Project Name: Community at Village Brook		
MEETING DATE: July 21, 2022	APPLICANTS: Jay Chrystal 14 Ben Farnsworth Road Brookline, NH 03033	APPLICATION TYPE: Site Plan – HOP APPLICATION NO: SP# 2022.B:H:042
APPLICATION STATUS: <input checked="" type="checkbox"/> Accepted: 65 days expires: 08.20.22 <input type="checkbox"/> Approved: <input type="checkbox"/> Extension:	APPLICANT'S REP: Meridian Land Services, Inc. Randy Haight, PE Trevor Yandow, PE 31 Old Nashua Road, Ste 2 Amherst, NH 03031	REVIEWED BY: Valérie Rearick, Town Planner Michele Decoteau, Town Planner First Review: 06.03.22 Third Review: 07.19.22
EXECUTIVE SUMMARY: The applicants are proposing a Housing for Older Persons Subdivision. The proposed subdivision should have 9 lots with 8 duplexes and 1 single family dwelling unit as well as a club house.

PLANNING STAFF APPLICATION REVIEW & COMMENTS.

**Re: Housing for Older Person Development, 23 Main Street (Map H, Lot 42)
Plan Review**

RE: Informal NRWA Review
Housing for Older Persons Development
23 Main Street, Brookline, NH

Calculation of drops in elevation PRE- and POST construction at X-intervals of 80 feet along Y-slices separated by 80 feet (see penciled grid on Meridian Land Services grading plan) (Note: Main Street lies near X=10; y=0,1, and=7slices not used) (Note: one inch on 11"x15" map = 80 feet on land)

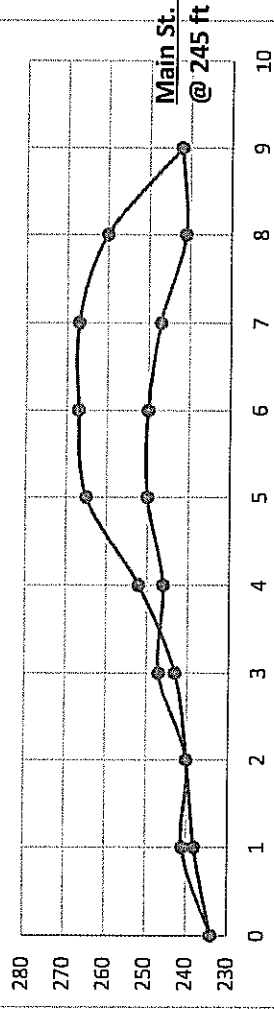
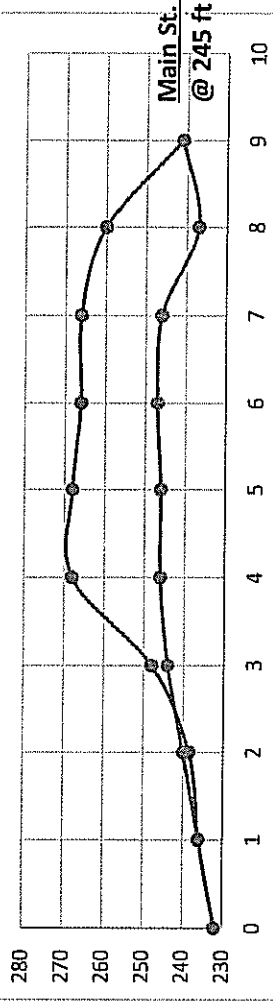
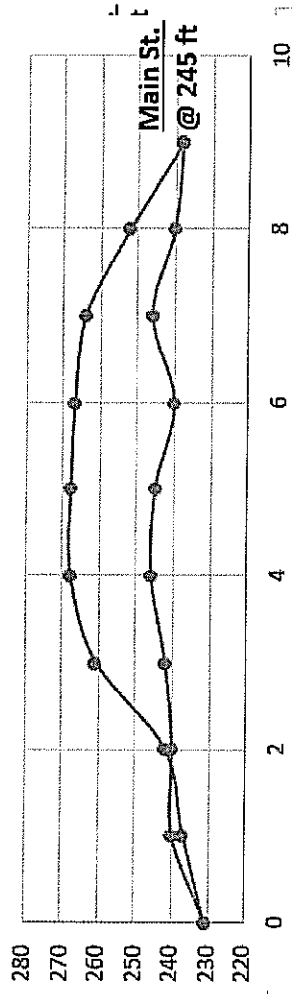
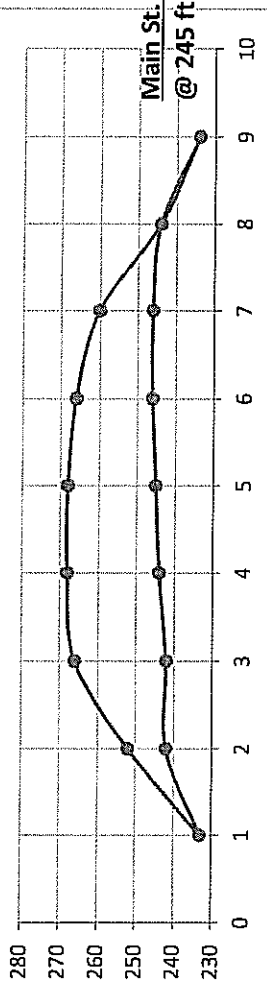
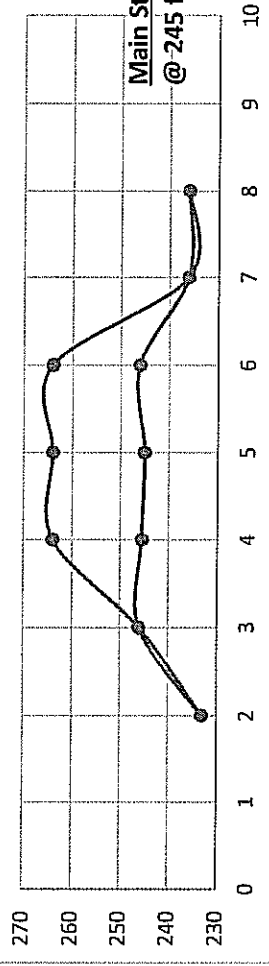
I examined and did a rough analysis of the Meridian Land Services drawings for the proposed development. Unless I am mistaken, the graphic scale presented in the lower right corner of the 8.5"x15" drawings is in error. The scale should be 1 : 80 (IN:FT), not 1:40.

By slicing the lot at 80 foot separations (horizontal lines in 1st attachment) and noting the depth of soil to be removed at regular intervals of 80 feet (vertical lines) and by plotting the results, one can visualize the contours of soil that will need to be removed. In the 2nd attachment, the blue curves show the present topography of the land (peak at 268') along the horizontal slices while the red curves show the proposed elevation (245') of the building site after removal of soil and boulders. The 245' elevation matches that of Main Street near Sargent Road. From this analysis, one can estimate the volume of soil/boulders to be removed at 3 million cubic feet. Assuming a dump truck capacity of 270 cubic feet, this corresponds to 11,000 dump truck trips

~ 3 million cu ft total volume of soil, boulders, rocks removed

~ 11,000 # of dump truck trips to haul away soil and rock

FRONT ELEVATION

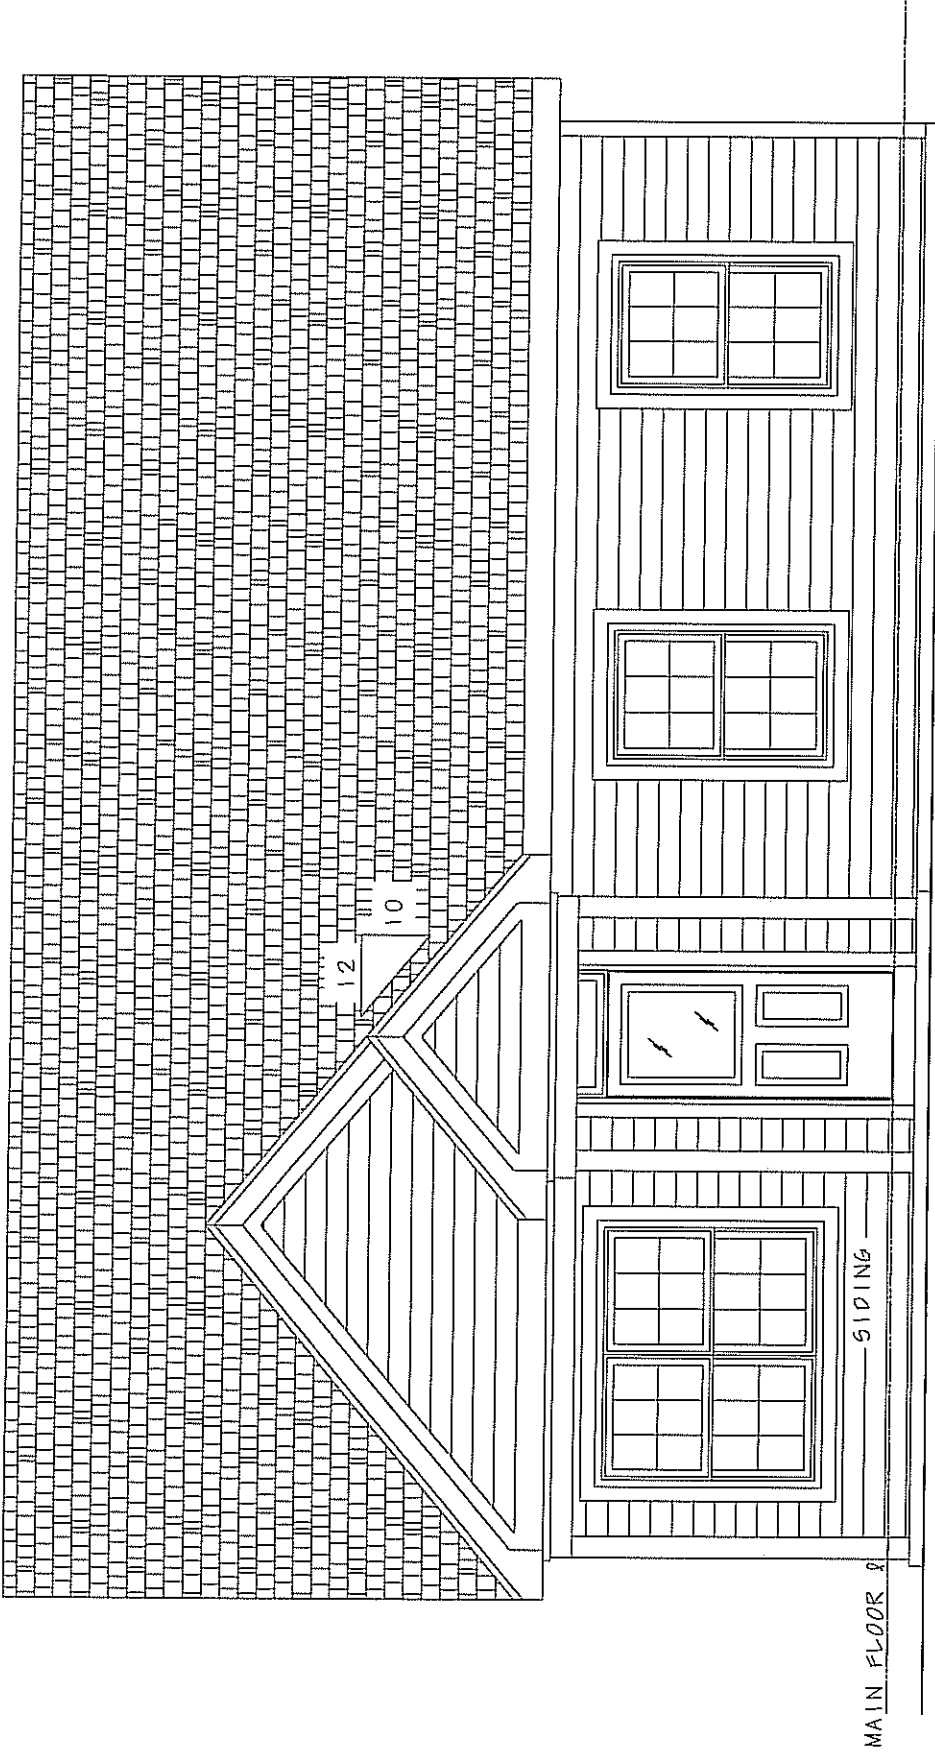
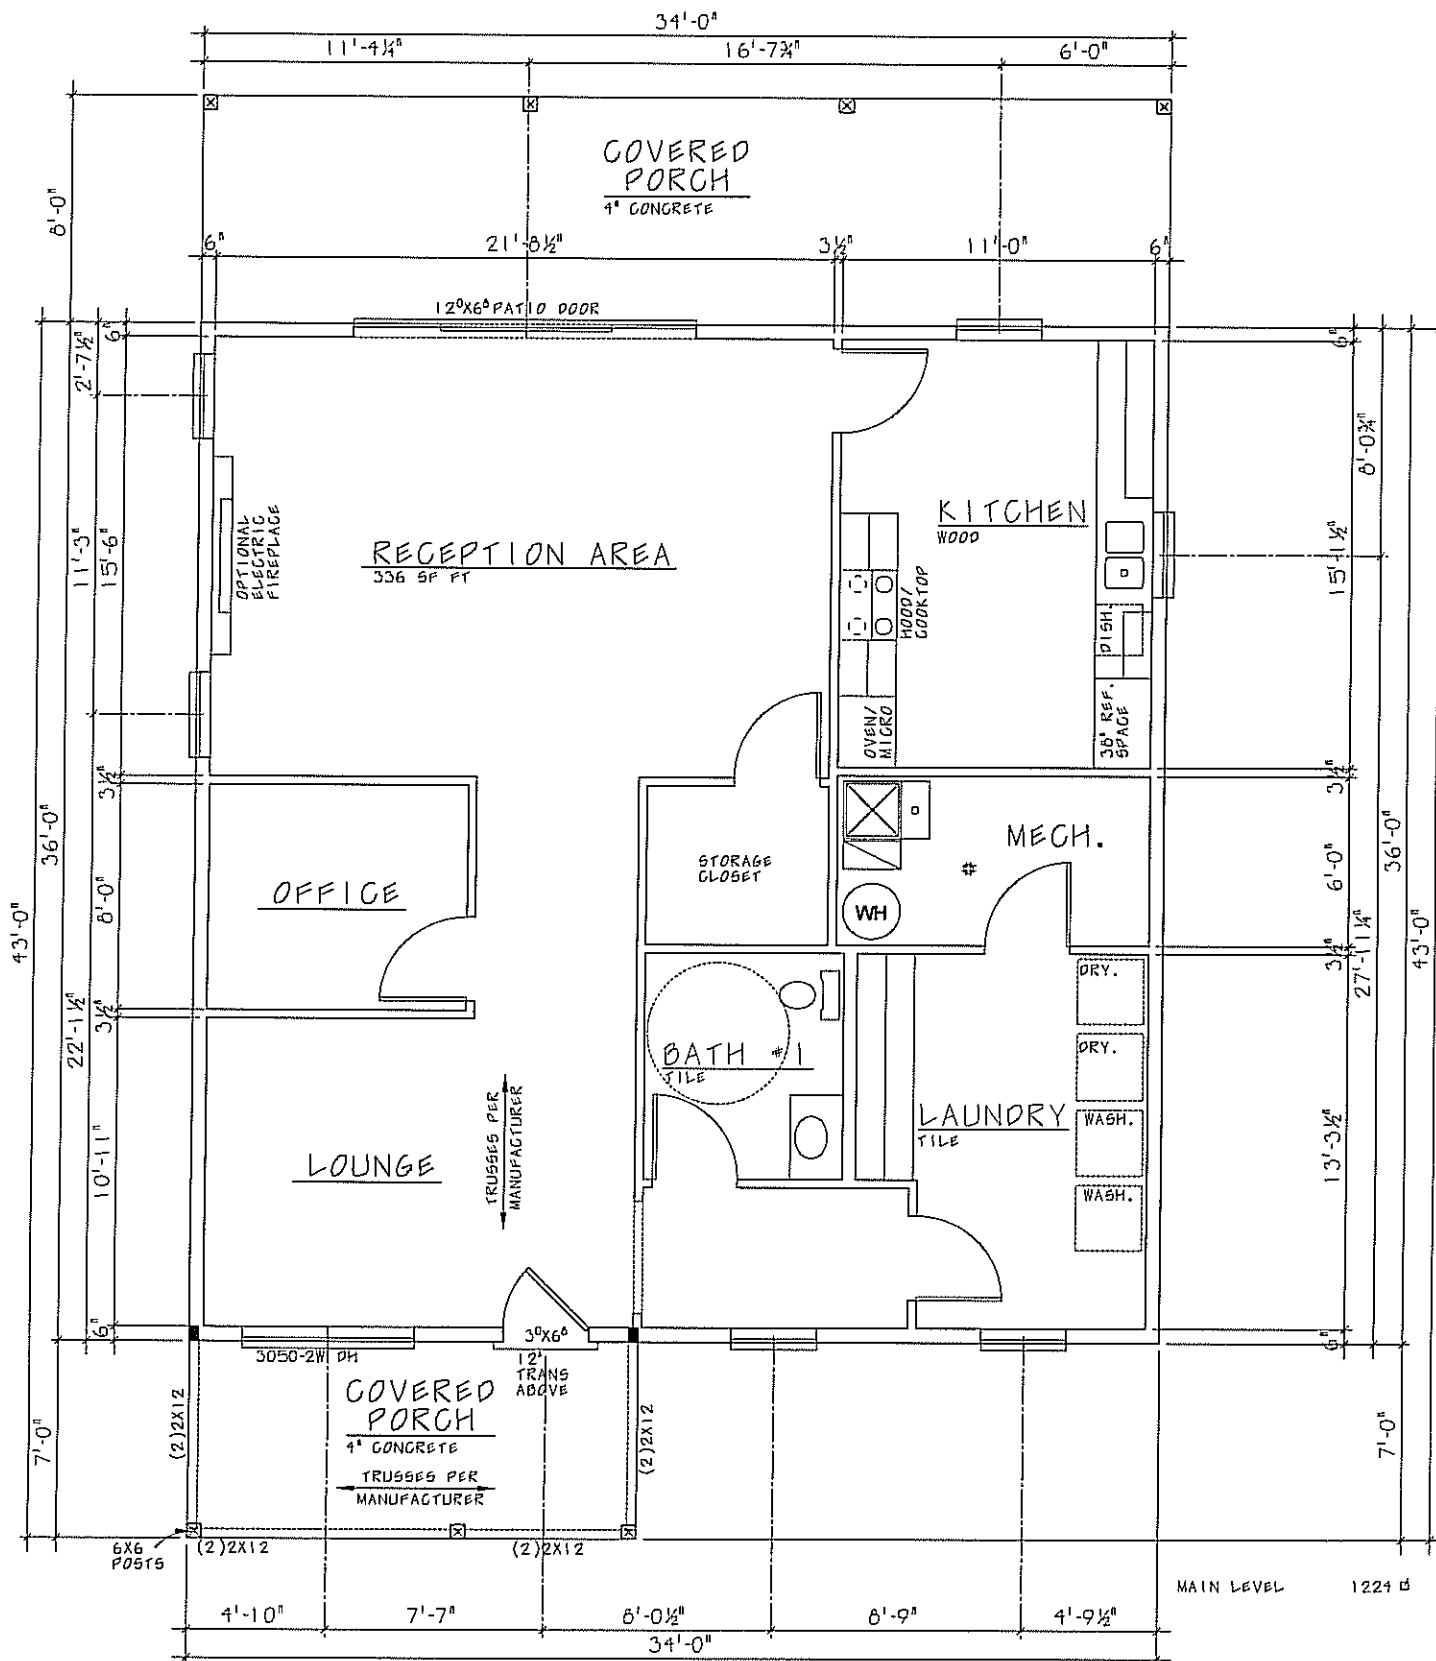
Separately, the fire department has reviewed the plans for the proposed club house at the housing for older persons at 23-25 main. Because this proposal meets the definition of an assembly occupancy it will have to meet the requirements set forth in both NFPA 1 and 101 2018 Eds. which includes but is not limited to:

1. Emergency lights
2. Exit signage
3. Proper size and orientation of means of egress
4. Fire sprinklers (NFPA 101 12.13.5.1(4))

5. If the meeting room in the club house is over 343 sq. feet or hold more than 49 people, the meeting room in the club house must have a commercial sprinkler system
6. Supervised fire alarm system
7. Carbon monoxide detection
8. The kitchen will need to have proper protection such as fire suppression and a hood system NFPA 96 2017 Ed.
9. The laundry room need to have a minimum of a 1hr fire separation (NFPA 101 12.3.2.1.2(2)(a))
10. The building will need to be inspected twice annually (NH RSA 155:34)
